Change Notice

Document No.	HRK-RD-26-10-29	Reviewer	Yongchan Kwon
Changes	PCB design, Capacitor		
Applicable Products	D950TW, D951TW, D946TW, D941TW		
Date of issue	2026-10-29		
Expected Time to Apply	November, 2026		
Title	Announcement - PCB design & Capacitor Change

Before change	After change

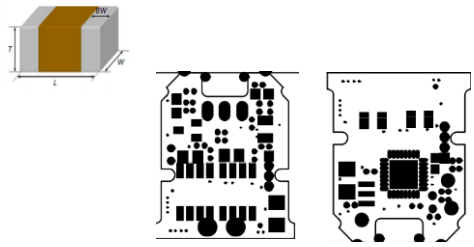
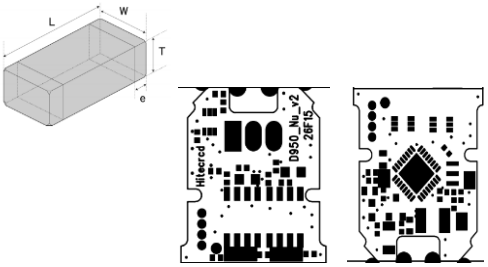
- Replace the existing capacitor with a higher-capacitance one to improve stability under unstable power supply conditions.
- Even if the change is applied, please note that the previous version of the stock would be shipped for a certain period
- We are striving to take preemptive measures to ensure that there are no problems with delivery time and quality, and we ask for your understanding of any inconvenience caused by changes.

※ Replace the capacitor with one that has a larger size, requiring a rearrangement of the PCB layout.
